**FINAL
BASIN A NECK
GROUNDWATER INTERCEPT AND
TREATMENT SYSTEM
INTERIM RESPONSE ACTION
ALTERNATIVES ASSESSMENT
VERSION 3.2**

SEPTEMBER 1988

RESPONSES TO COMMENTS OF
COLORADO DEPARTMENT OF HEALTH ON
DRAFT FINAL BASIN A NECK GROUNDWATER INTERCEPT
AND TREATMENT SYSTEM INTERIM RESPONSE ACTION
ALTERNATIVES ASSESSMENT

Figure 4-1

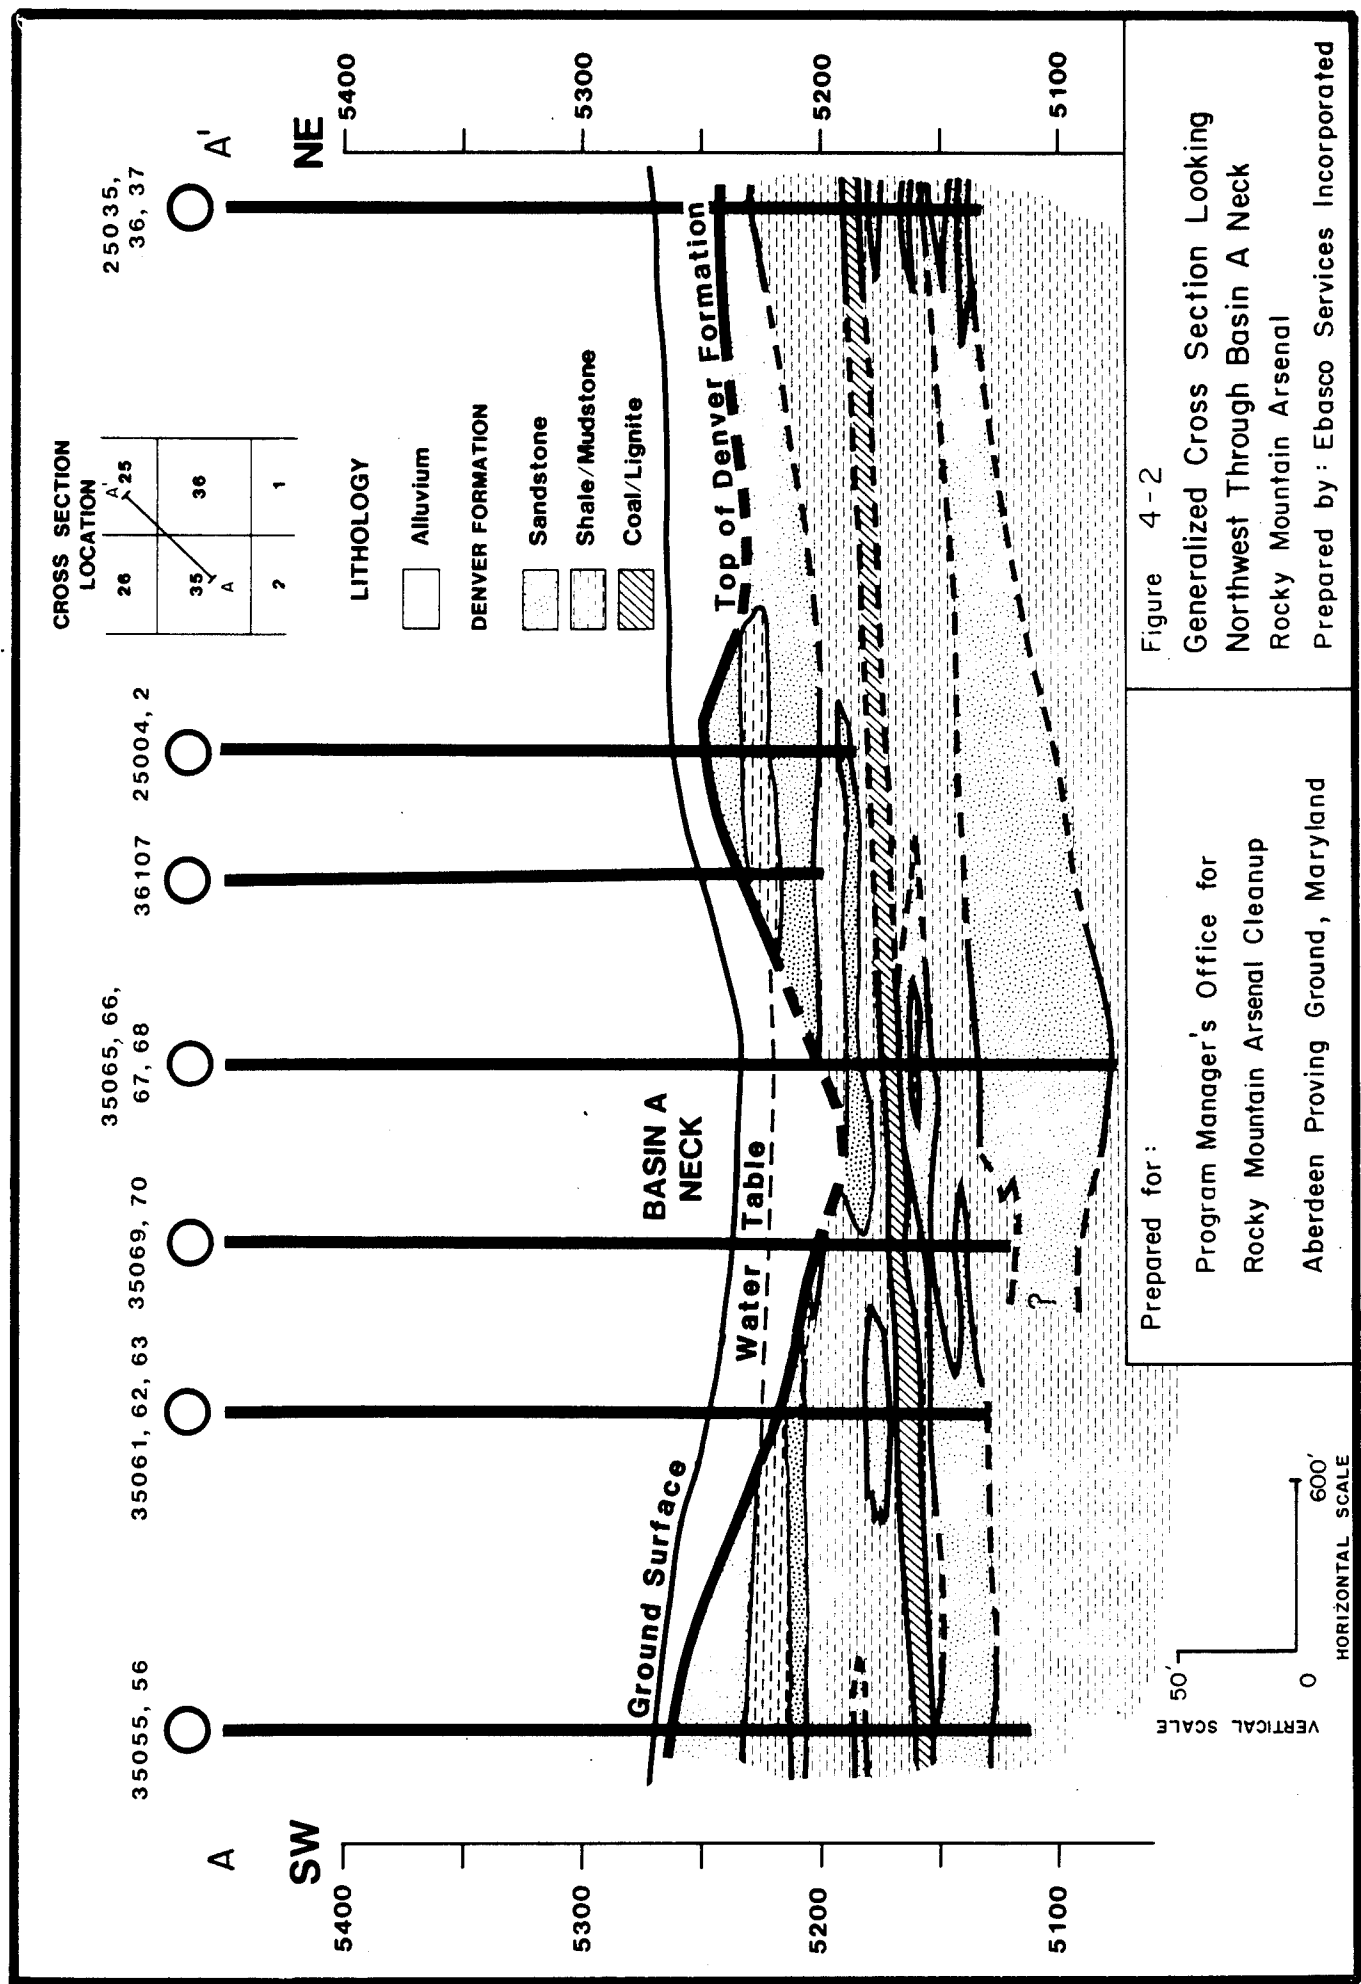
Construction in areas utilized by bald eagles has so far been restricted during the period November 1 to April 1. Bald eagles are known to use portions of the area mapped in Figure 4-1 of the Assessment document. Depending upon the final selection of the response alternative and the contaminated areas to be affected by construction, we recommend you contact either Mr. Pete Gober in Golden (236-2675) or Mr. Mike Lockhart of this office (303-243-2778) for specific guidance required to insure against unnecessary disturbance of wintering bald eagles.

Figure 4-4
Well Location Map

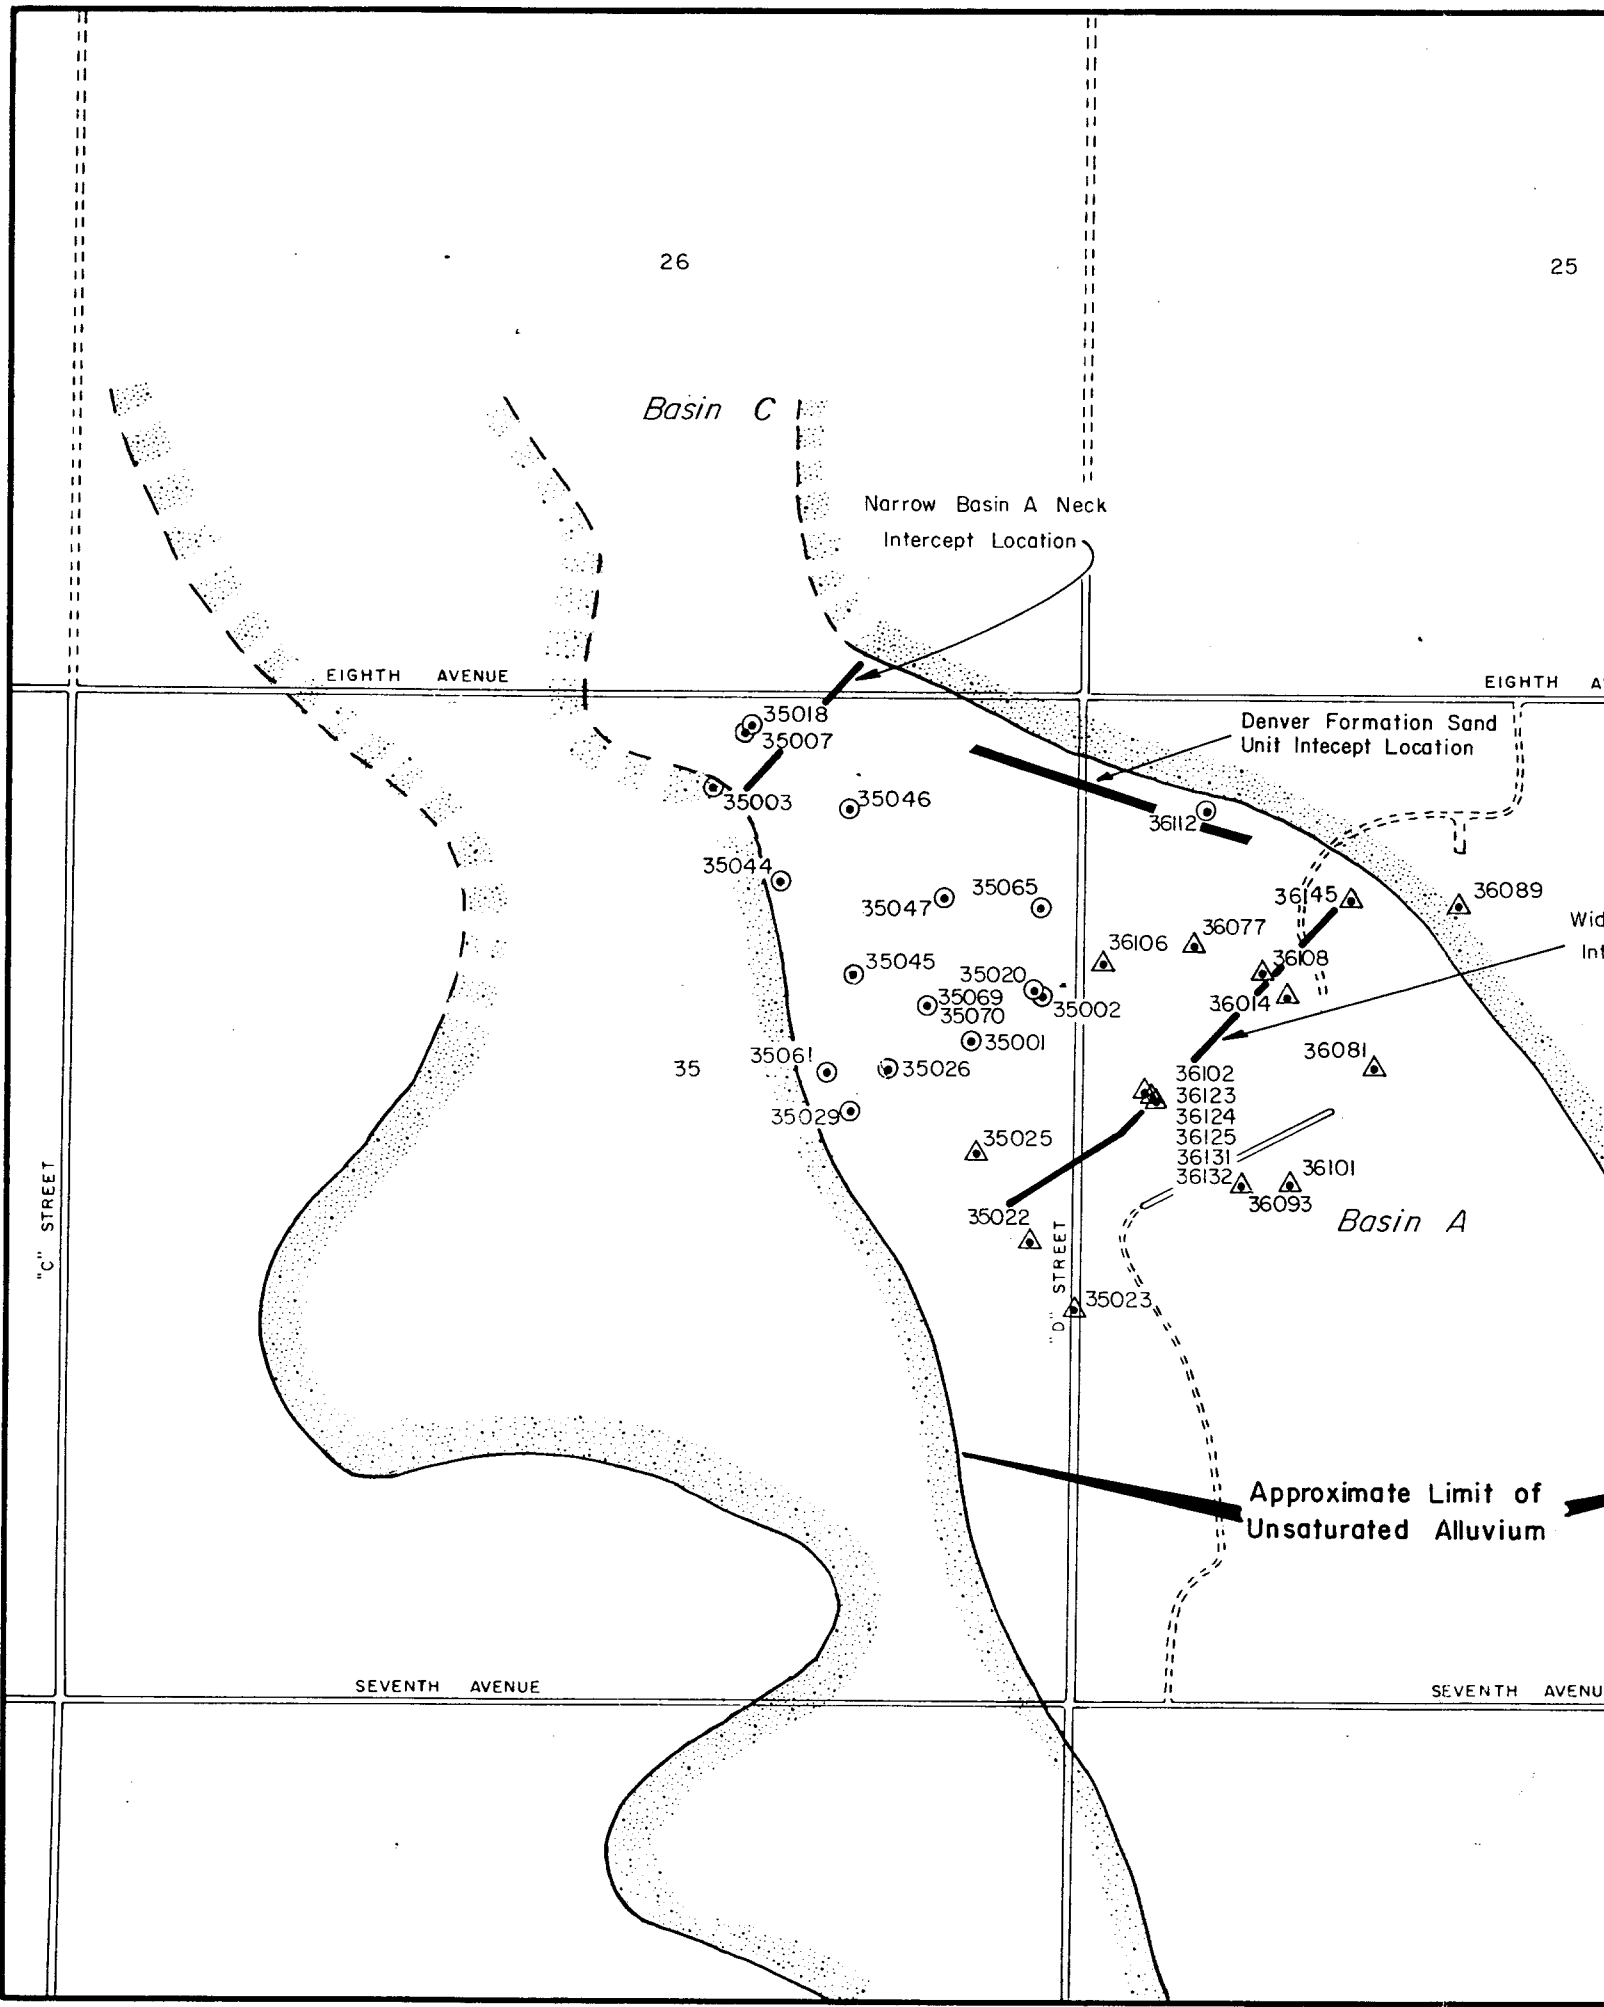
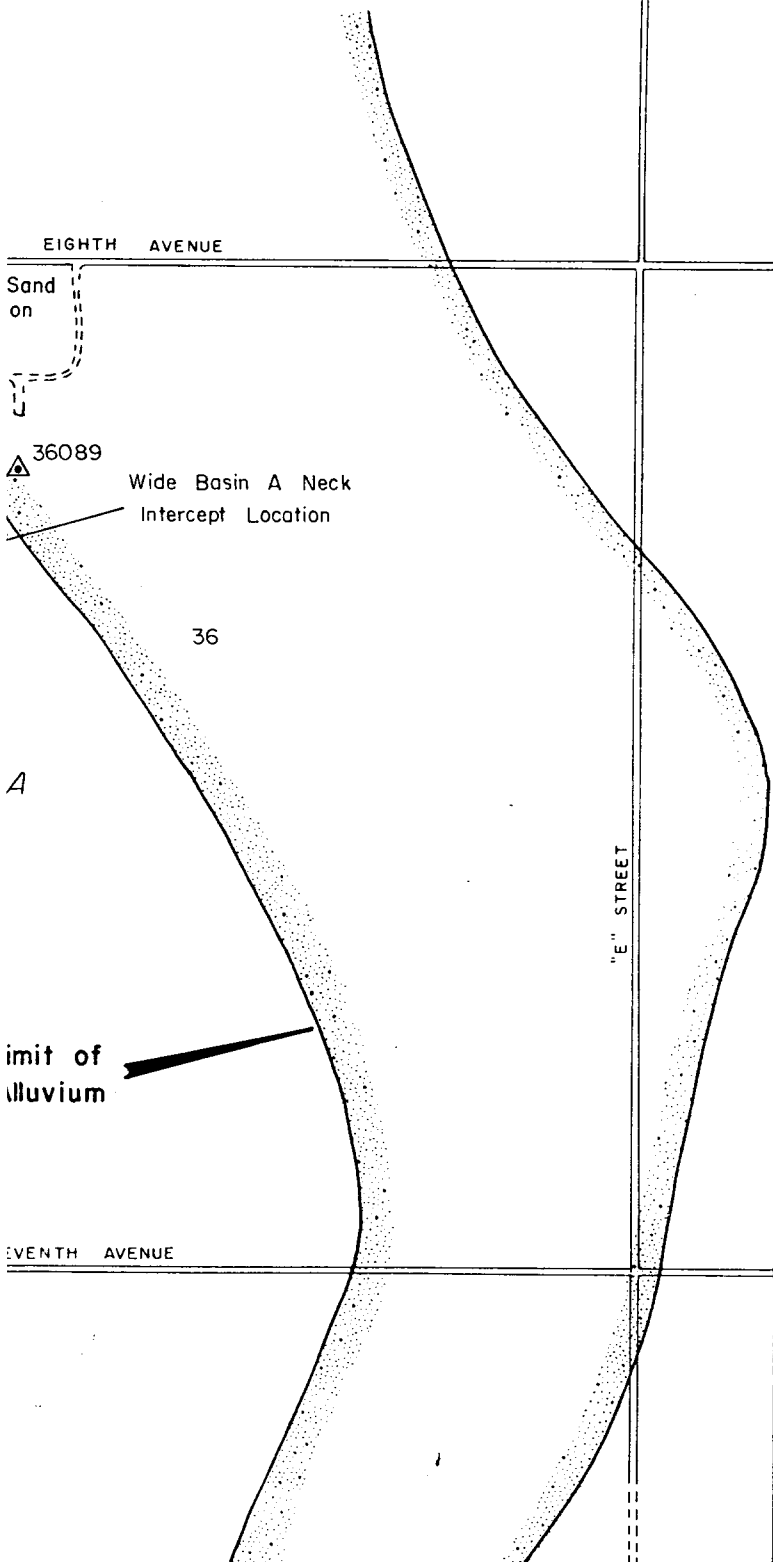
Comment 7: Pg. 42, Table 6.2-1 - Has the remote (Denver formation) component of the proposed narrow Basin A neck system been included in all cost estimates? This report should include separate cost estimates for the two components of the narrow Basin A neck system.

Response: The extent of lateral Denver Formation sand units has not been established. The location shown in Figures 4-1 and 4-4 is conceptual and is not intended to delineate the size of the system, only its approximate location. There is insufficient data at this time to develop costs for the remote Denver Formation component of the intercept system. The costs presented in Table 6.2-1 do not reflect the costs associated with the remote system. The text has been modified to clarify this point.
